WARRANTY BULLETIN

WB20-04

DATE :	October 2021	SECTION :	18 BODY	
EXPIRATION:	October 2023			
SUBJECT :	COMPRESSOR DOOR HANDLE REPLACEMENT

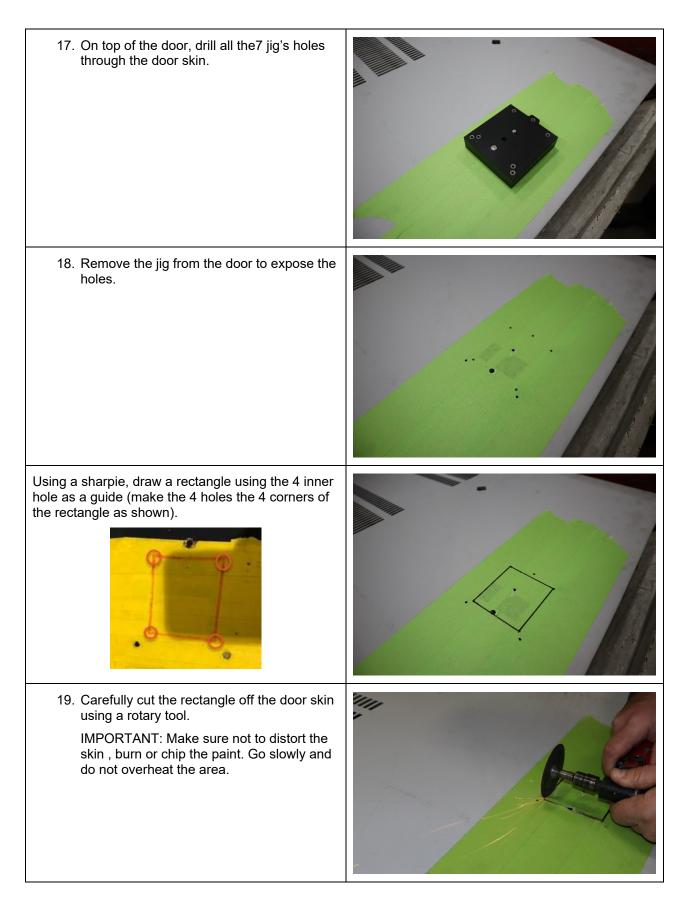
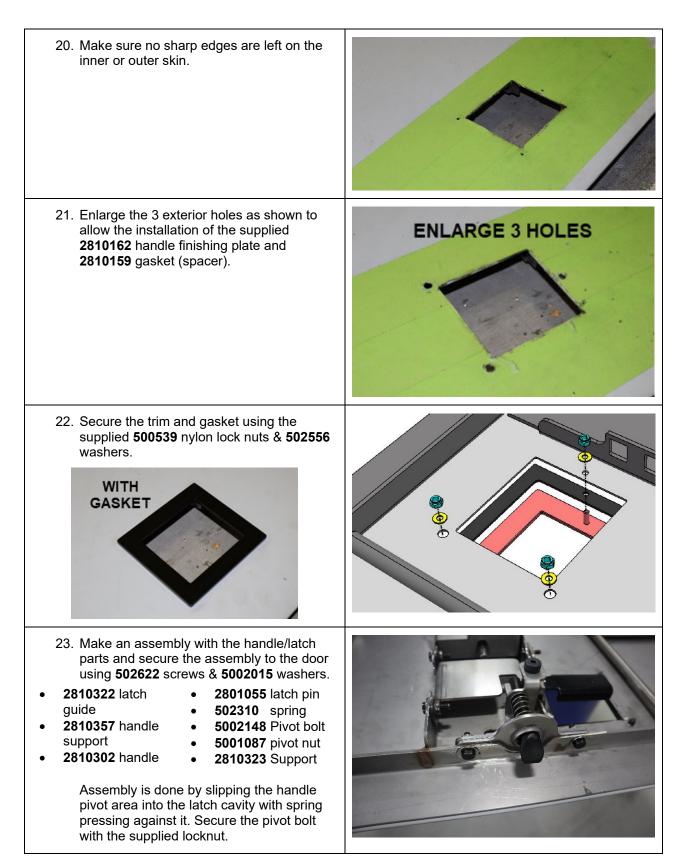
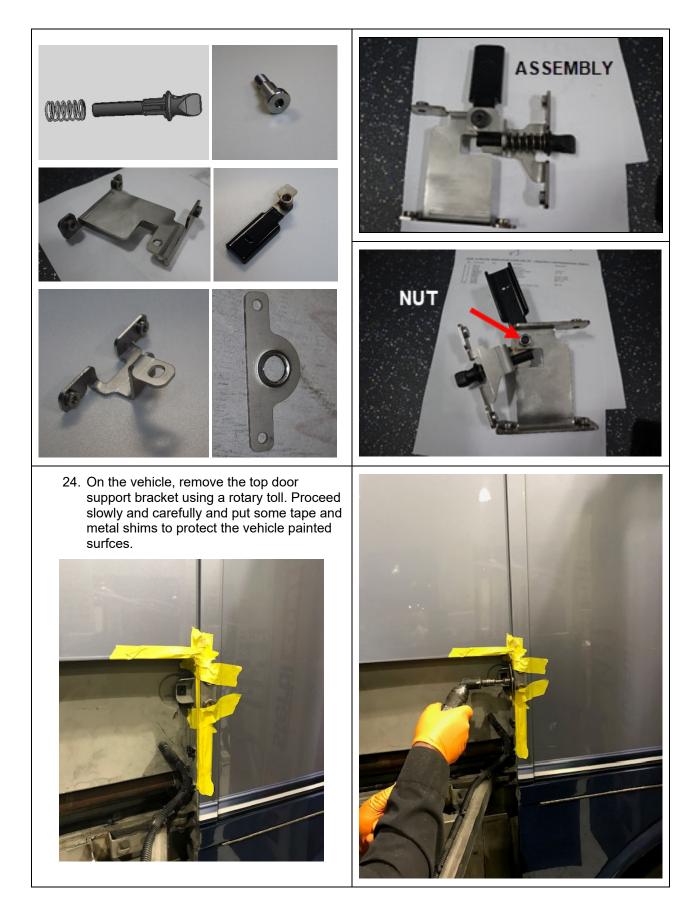
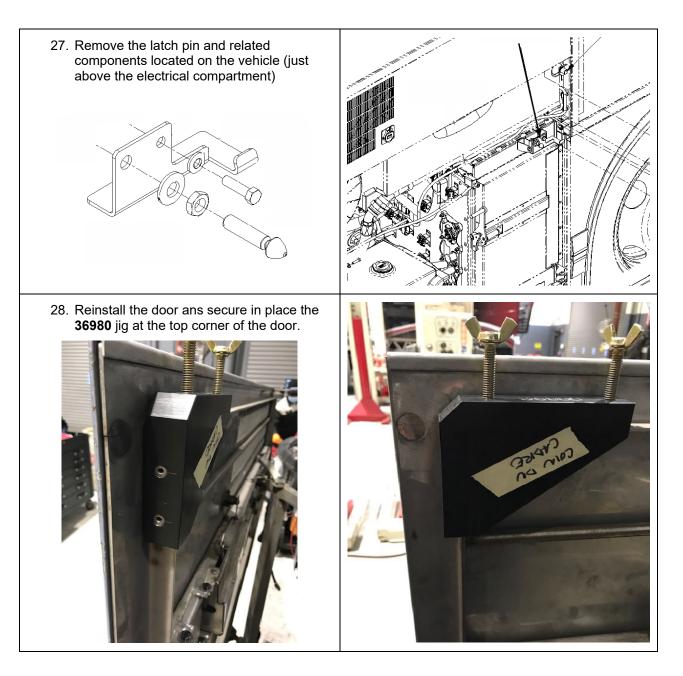
On the vehicles affected by this bulletin the compressor door handle must be replaced by an improved unit with more positive latching fell and better ergonomics. A top corner support must also be added to reduce door movements and road noise during operation.

6. Using a sharpie, mark the half-moon area where the new latch pin will be installed	
7. Grind the area using a suitable die grinder and smooth the edge of the cut.

8.	Install the <b>36979</b> jig over the mechanism area and tighten in place.	
9.	Make sure that there is no gap between the top of the door frame and the bottom of the jig's groove as shown.	
		NO GAP ()

10. Using a long and slightly flexible drill bit (or an angle drill), drill the 3 necessary holes in the door structure (use jig as a guide to drill the 3 holes).	
11. Enlarge the 3 holes enough to accept the 3 mounting screws supplied in the kit.	ENLARGE 3 HOLES

<ul><li>12. Flip the door 180 deg on the table to expose the exterior (painted) side.</li><li>13. Put some masking tape around the door handle opening.</li></ul>	
<ul> <li>14. Install the <b>36940</b> door opening jig over the door opening</li> <li>15. Make sure the 2 locating pins are inserted in the door.</li> <li>16. Tighten the jig from the underside as shown.</li> </ul>

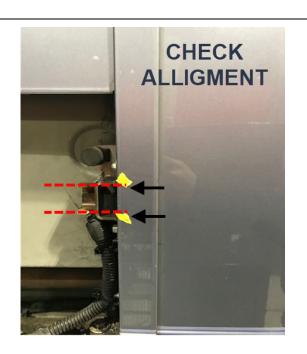
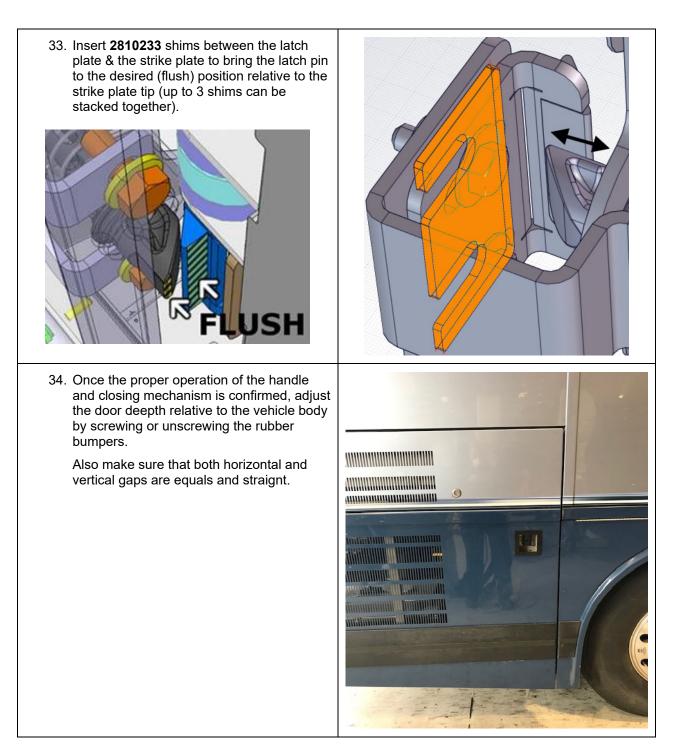
- 29. Mark the two drill points on the door frame (do not drill yet)
- 30. Make sure that the lower drill point is located in the middle of the new upper support "U" shaped part. Adjust <u>both</u> drill points as necessary.

Install the 280589 door roller (5001461 tapered screw, 2810149 retaining plate, 500119 screw, 5001849 washer & 5001787 nuts).

32. Secure the new **2810358** latch plate, **2810232** strike plate & **2810360** backplate to the vehicle using four **502622** screws & four **5002015** washers.
